Urban Design Review

Project	Coles Wilton – 30 Pembroke Parade, WILTON
KAA Project No.	2249
Date	02 May 2025
Revision	2

This proposal, Scheme B, is the fourth that KAA has reviewed.

<p>Scheme A - KAA recommendation</p>	 <p>Scheme B (DA011)</p>

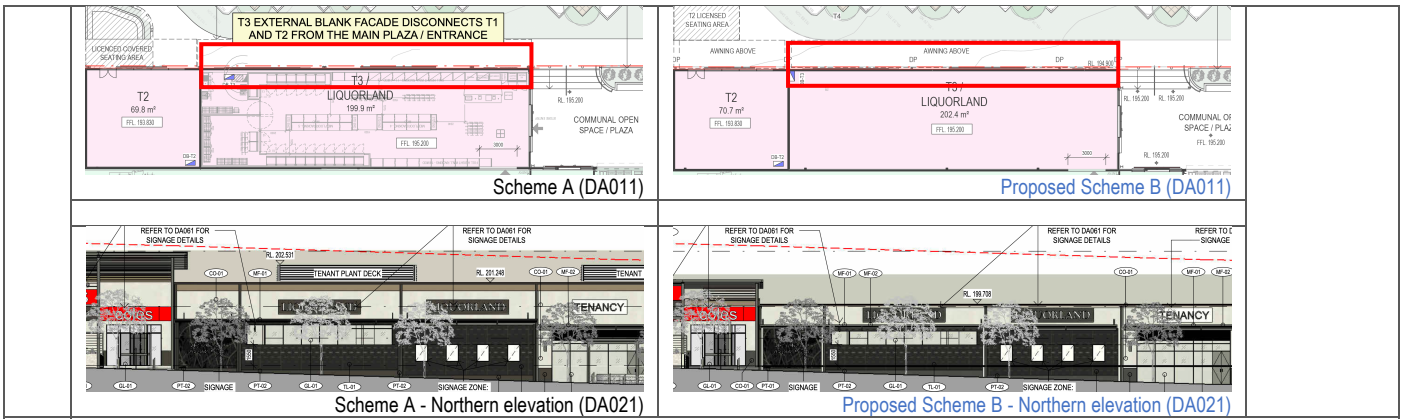
No.	KAA Comments – Scheme A	KAA Comments – Scheme B	Addressed
1.	Street Crossing		
	<p>The proposed pedestrian crossing retains existing street parking which, on its western side makes the path of travel to the Supermarket entry slightly awkward. The 'desire' line to the entry will be across the grassed area outside Tenancy T4.</p> <p>KAA recommend that:</p> <ul style="list-style-type: none">the public area between the building entry and pedestrian crossing be redesigned to create a better path of travel and larger paved area, with possible location for bicycle stands, bins etc  <p>Scheme A (DA011)</p>	<p>KAA:</p> <p>Scheme B removes:</p> <ul style="list-style-type: none">proposed new pedestrian crossing at Greenbridge Driveproposed street trees fronting T4garden bed within the seating area fronting T4the awning structure over the seating area for T4 <p>Scheme B reduces the path of travel width to the plaza to 1.5m.</p> <p>KAA's previous recommendation has not been addressed, resulting in a narrower pedestrian path with awkward sharp turns leading to the plaza.</p> <p>It is recommended that the removal of the garden bed and trees be reconsidered to create a more welcoming and pedestrian-friendly environment.</p> <p>Additionally, the potential for incorporating bicycle parking, as previously suggested, could lead to better outcomes for the plaza.</p> <p>In KAA's opinion:</p> <ul style="list-style-type: none">KAA's earlier advice, should be adopted	✗

4. Facades

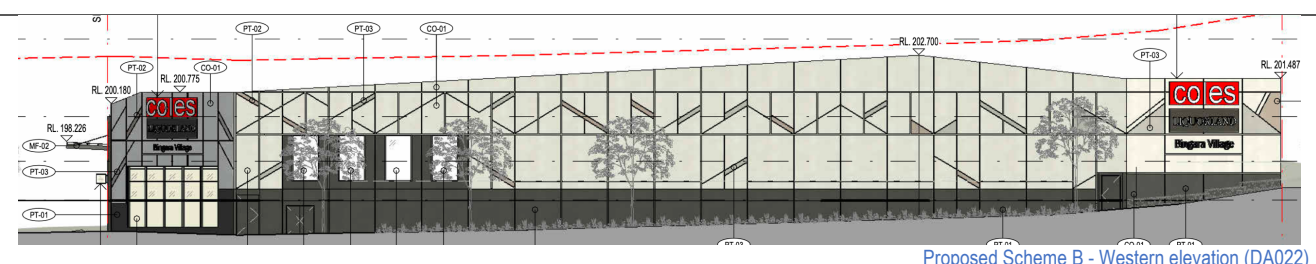
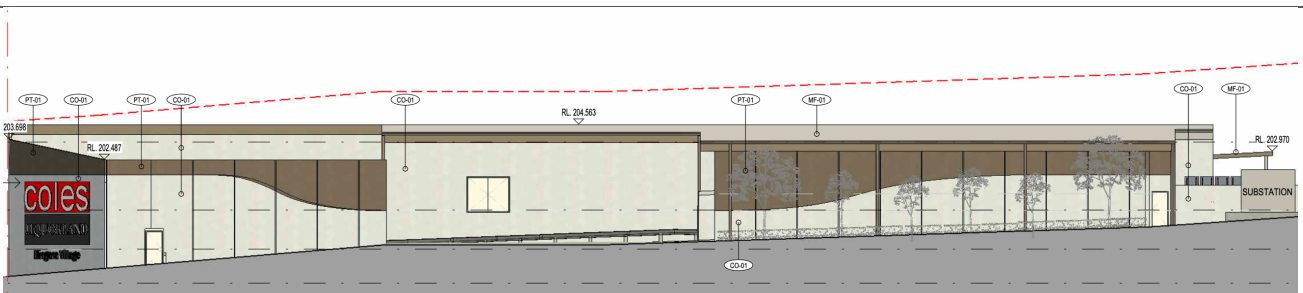
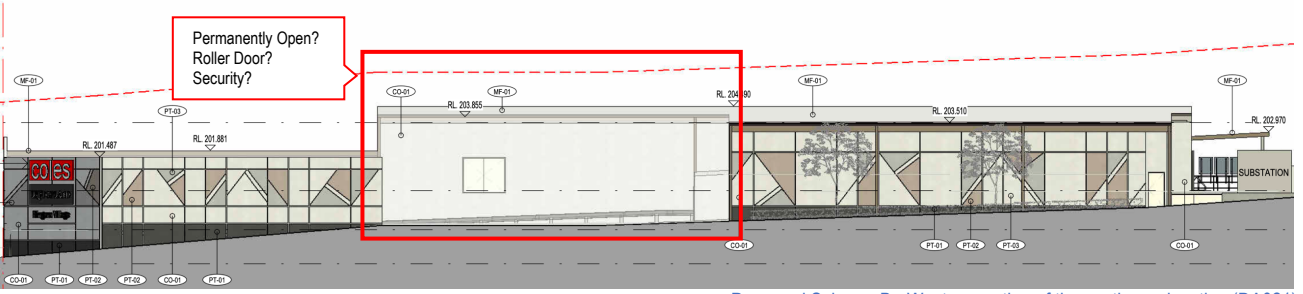
The western façade facing Pembroke Parade is both the most substantial in terms of height and most exposed in terms of visibility.

The central blank portion of the façade is approximately 45m long and 9m high. It has a significant presentation to Pembroke Parade which is the primary thoroughfare entering the Bingara/9410a Gorge.

The design does include a number of street trees plus planting, but the landscape design is less pronounced than elsewhere and in KAA' opinion, the expression of a largely unarticulated blank face with only a paint treatment is not what is required for this significant and prominent location and entry to the town centre.

Though not stated the building, particularly the Pembroke Parade facade appears to be constructed of vertical precast concrete panels, more normally associated with warehouses and factory complexes in industrial areas.

In KAA's opinion, the western façade facing Pembroke Parade needs reconsideration to increase its visual quality, activation and articulation.

This could be achieved through a combination of elements such as wall recesses, glazing, vertical battens, planting, green walls, paint, murals, signage and the like.

For example, some continuation of the vertical screening (MF-04 on Drawing DWGDA022) to the large blank walls could, in combination with other elements, increase the coherence of the scheme as a whole as well as improving its street presentation.

- the western façade facing Pembroke Parade be reconsidered to improve its street presentation

- height:** the reduction from over 9 metres to approximately 7.5 metres reduces the bulky appearance of the façade and better aligns it with the surrounding context

- façade / appearance:** abstract geometric patterns, vertical and horizontal elements, and a revised colour palette address the previous concerns raised about the industrial character

- articulation of the central portion:** abstract geometric patterns with horizontal and vertical elements break the linearity of the large blank façade, improving the streetscape and visual interest

- colour palette:** Colourbond concrete finish, paired with Colorbond Dune and Colorbond Southerly in the multi-tone palette, creates an engaging façade

- high-level glazing in the north-west corner:** promotes the building's interaction with the streetscape, breaks up the large façade, and allows natural light into the supermarket

- planting along the frontage:** softens the façade, integrates with the urban landscape, and improves the pedestrian experience

In KAA's opinion, the proposed changes represent a significant improvement over the original façade design, addressing the concerns raised previously.

Scheme B enhances the visual quality, articulation, and activation of the façade, improving the building's contribution to the streetscape of Pembroke Parade.
